AMENDED
01 NOV 2013
BY ZOE ECA
(name)
MEDQ

CLIENT
ECONOMIC DEVELOPMENT
QUEENSLAND
PROJECT
HILLCLOSE
HARVEY ROAD
CLINTON

PLAN OF DEVELOPMENT
STAGE 4, 4B,
7A & 7B
ALLOTMENT LAYOUT

PLANS AND DOCUMENTS
referred to in the PDA APPROVAL
05 NOV 2013
MEDQ

CONCEPT ELEVATIONS

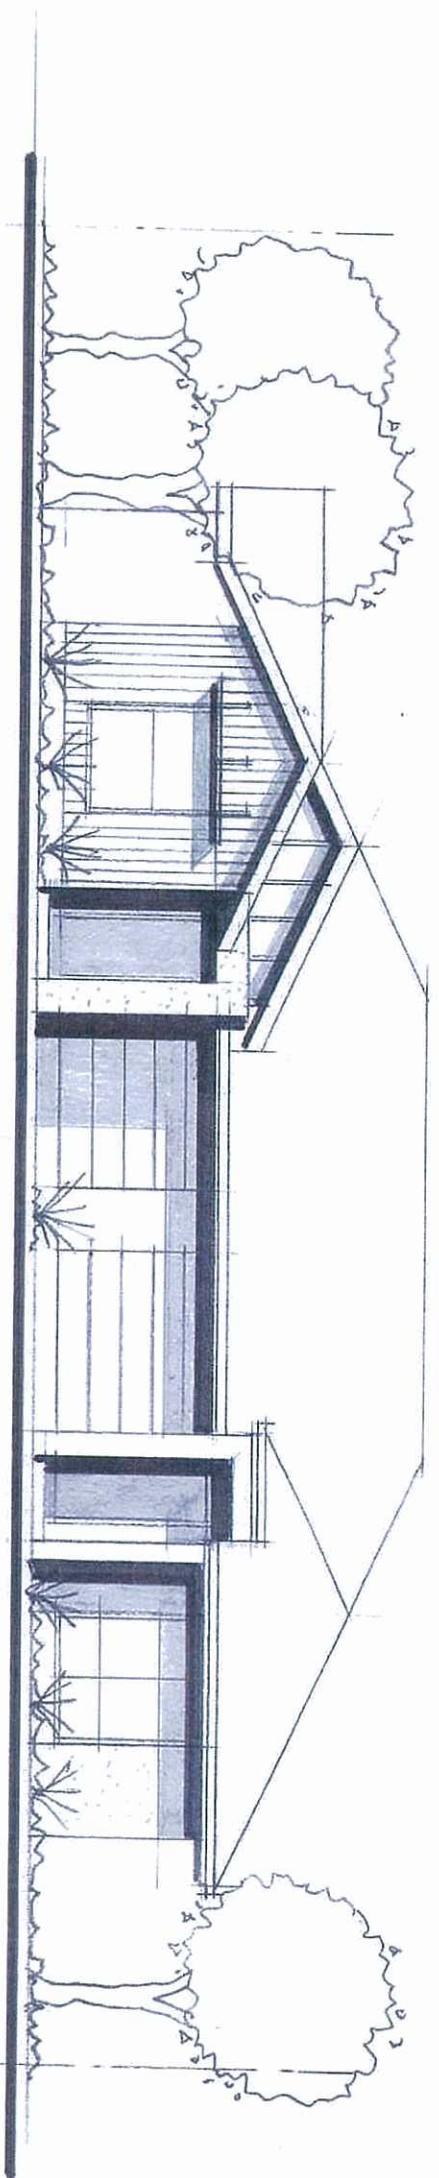
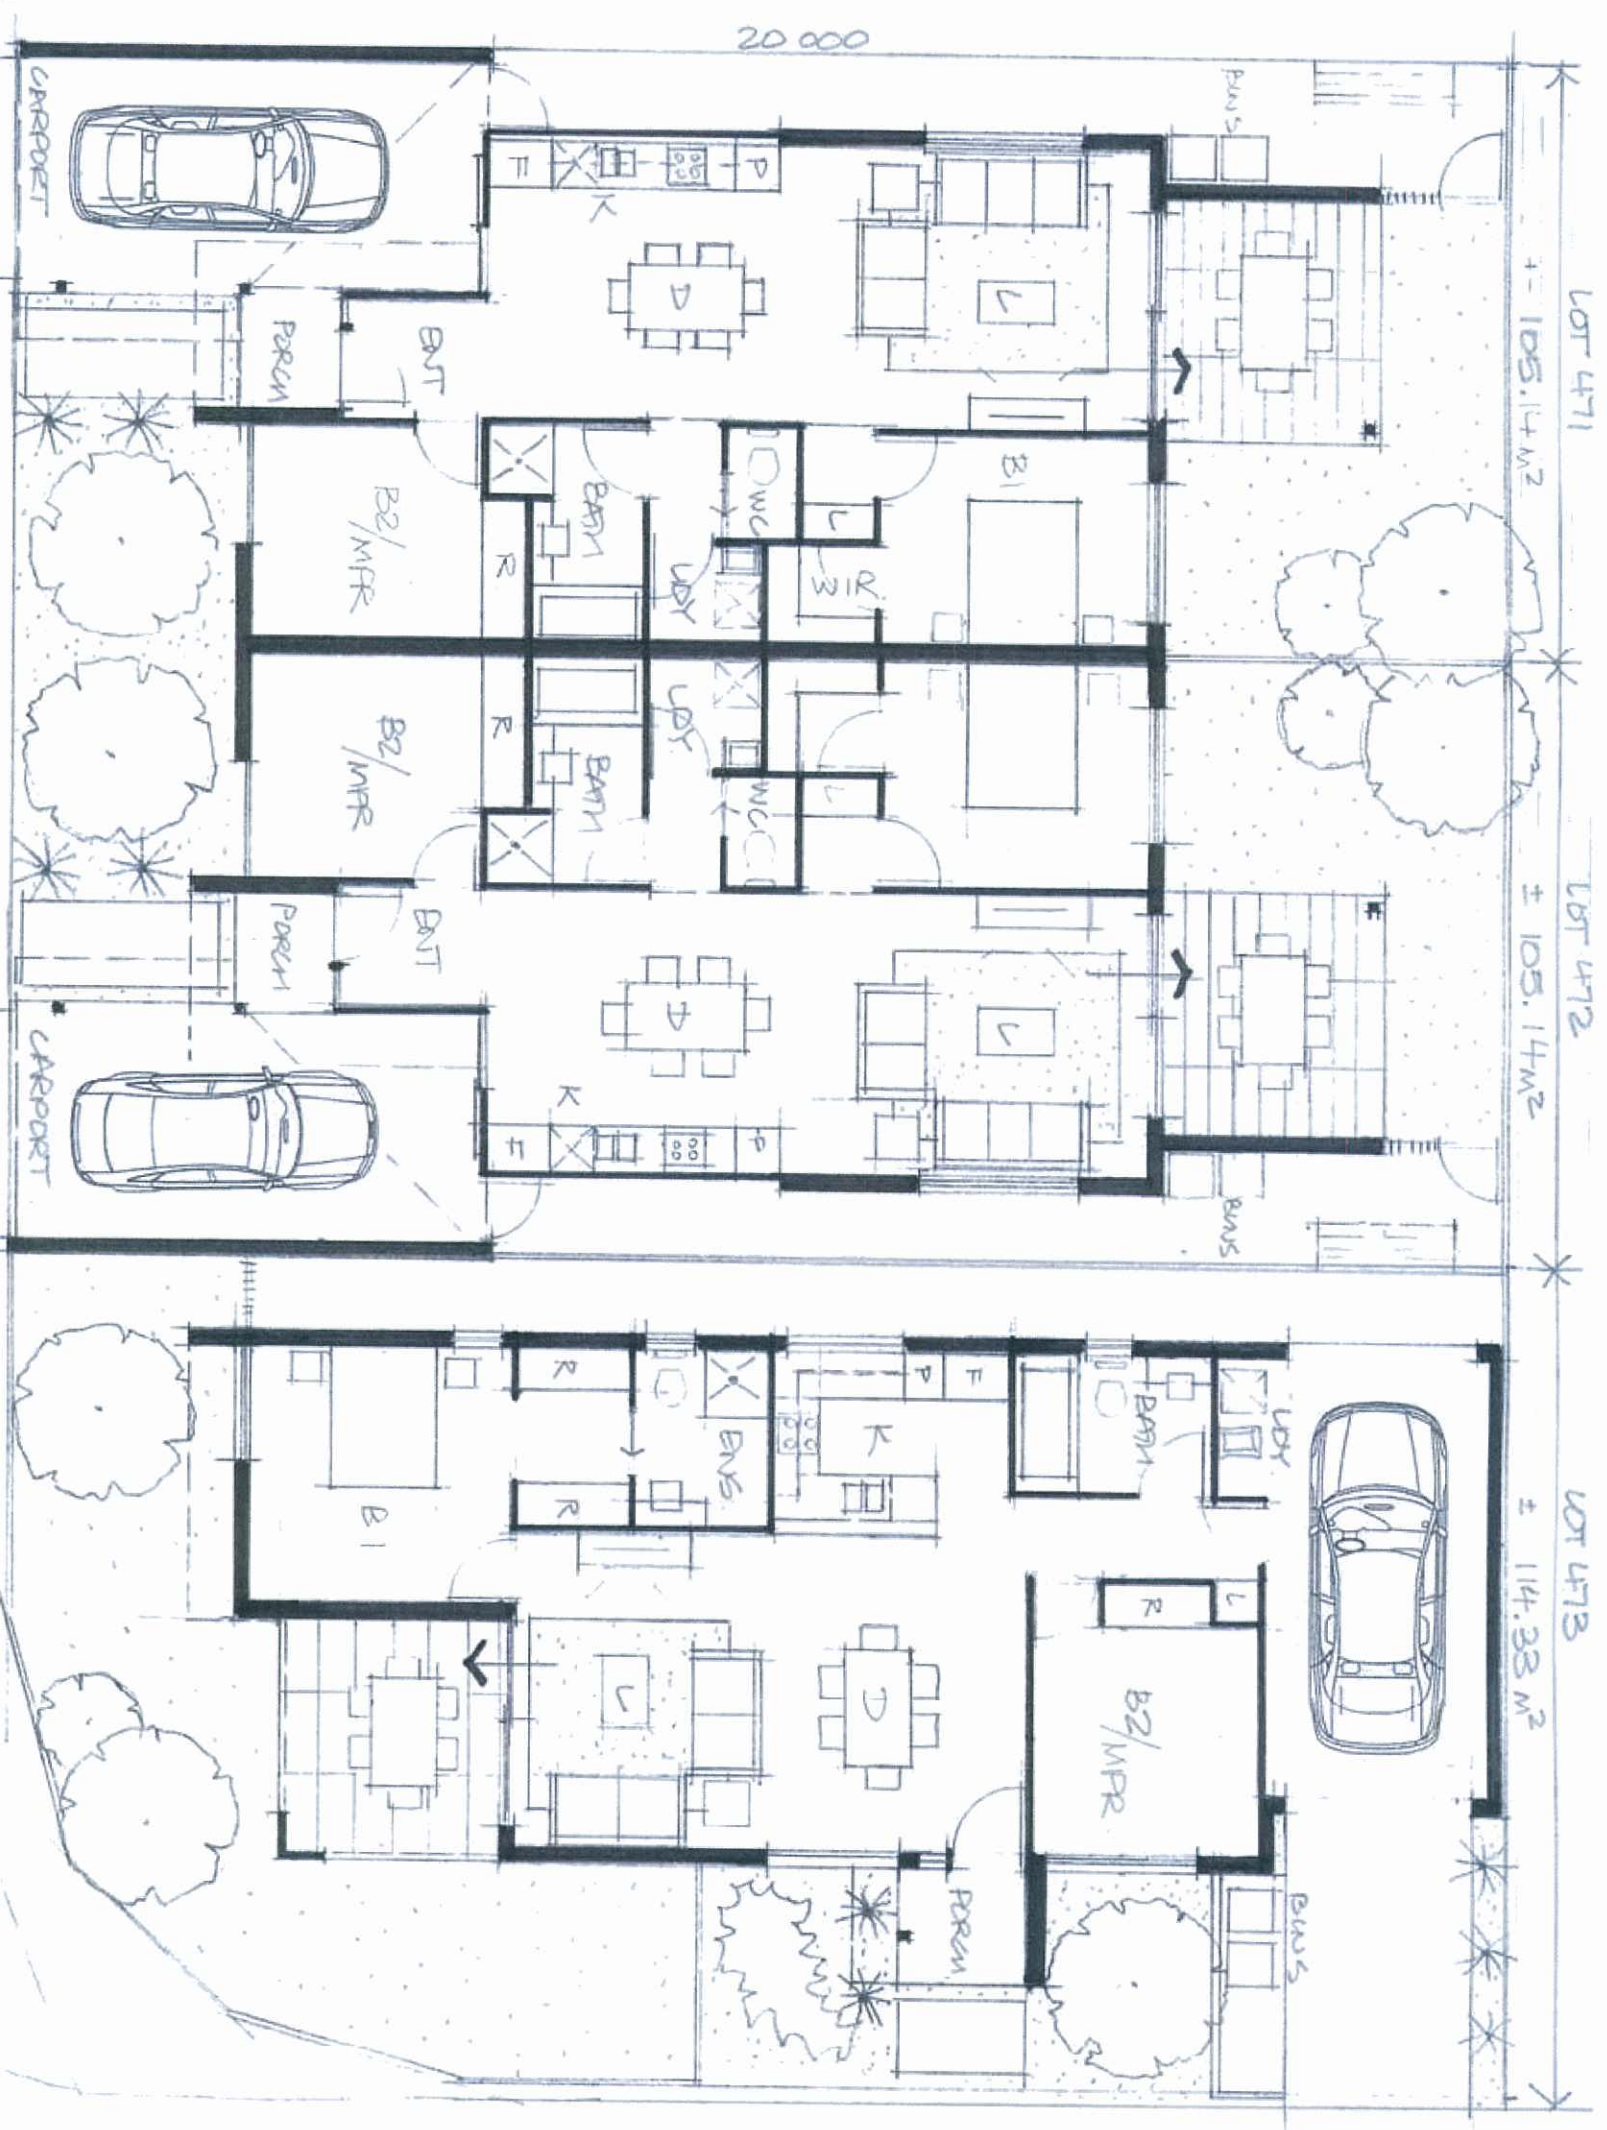
A MENDED IN RED
1 8 SEP 2012

HILL CLOSE ~~386-387~~

Client: ~~388-389, 404-405, 427-428 and 443-444~~

Site: LOT ~~386-387~~ HILL CLOSE ESTATE

STAGE 4 & 7 - HILL CLOSE

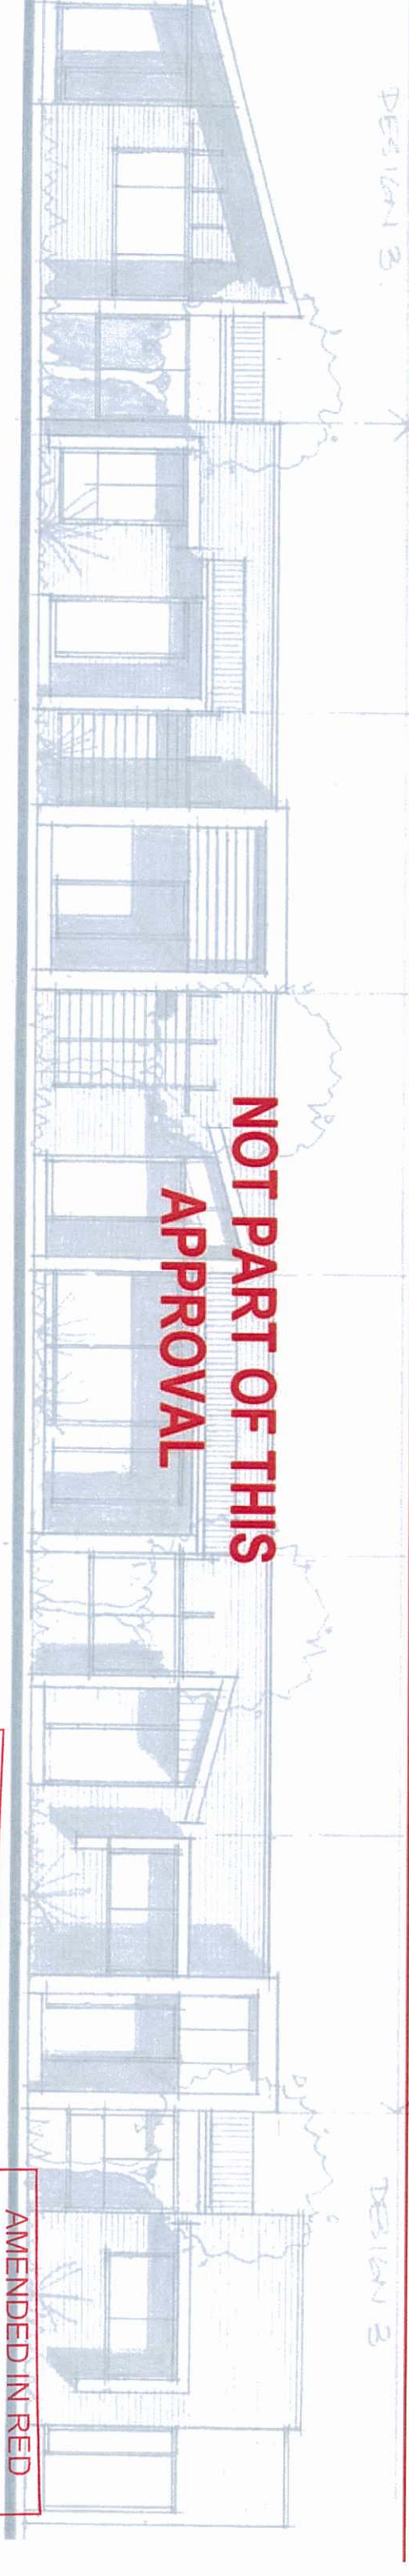
~~Lots 525 to 529 are 285sqm. The following design applies and forms part of the DA if lots are subdivided. All lot designs require formal submission for design guideline approval.~~

**NOT PART OF THIS
APPROVAL**
